INITIAL FIRE SAFETY INSPECTION REPORT

Alim Knit (BD) Ltd (Extension)

RSC ID: 24780

Date: 24th December 2023

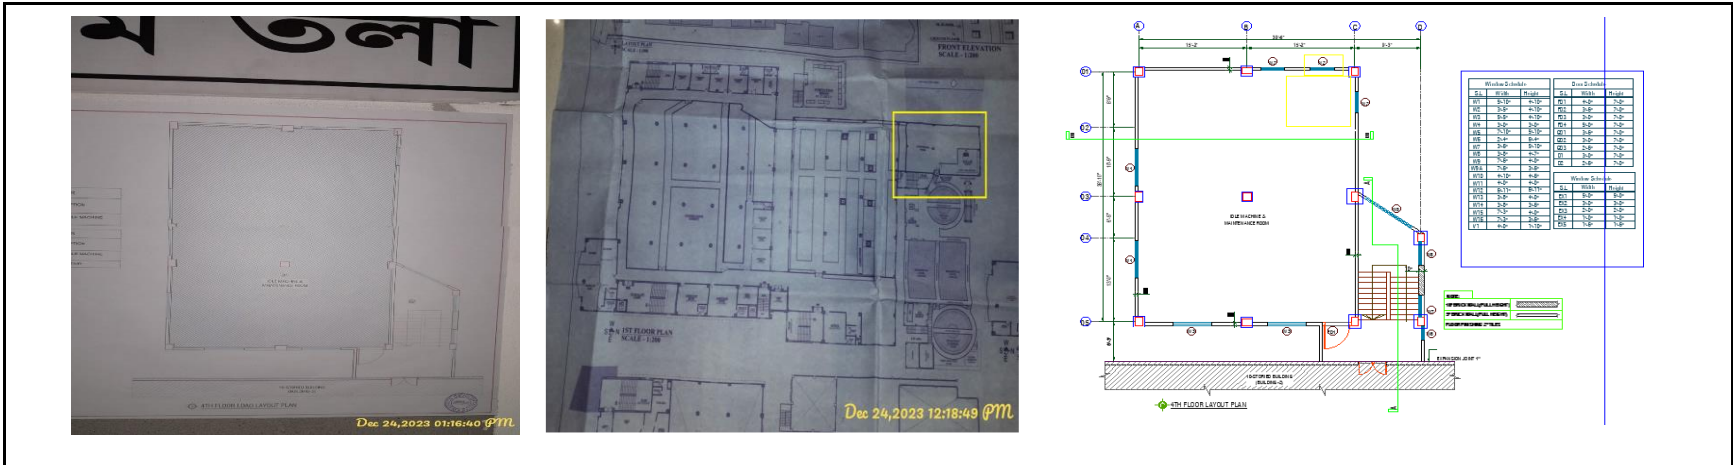
F-5	Fire Rated Construction	<p>The factory is using/storing liquified gas cylinders without proper separations</p> <p>Location: Ground floor of the building-3.</p>	<p>The factory shall follow TECHNICAL GUIDANCE NOTE FOR USE OF LIQUIFIED OR COMPRESSED FLAMMABLE GAS IN THE FACTORY PREMISES.</p> <p>LPG/CNG cylinders are permitted to be stored in a separate dedicated building on the factory premises within its boundaries if the building meets the following conditions.</p> <ol style="list-style-type: none"> 1. The storage building must be at least 3 meters away from any other building and boundaries. 2. The exterior walls of the building must have a fire resistance rating of 3 hours using noncombustible construction. 3. Doors and other openings in the exterior walls must be protected with suitable closing devices having a fire protection rating of 3 hours. 4. The building is to be used for no other purpose than the storage of LPG/CNG cylinders. 5. The building must be mechanically ventilated to control the accumulation of flammable vapors. 6. The installations must be approved and accepted by the requirements of the AHJ, Gas supply company regulations, manufacturers/supplier's instructions/guidance, Chief Inspector of Boiler (CIOB) and Chief Inspector of Explosives Bangladesh (CIEB). 	within 3 months
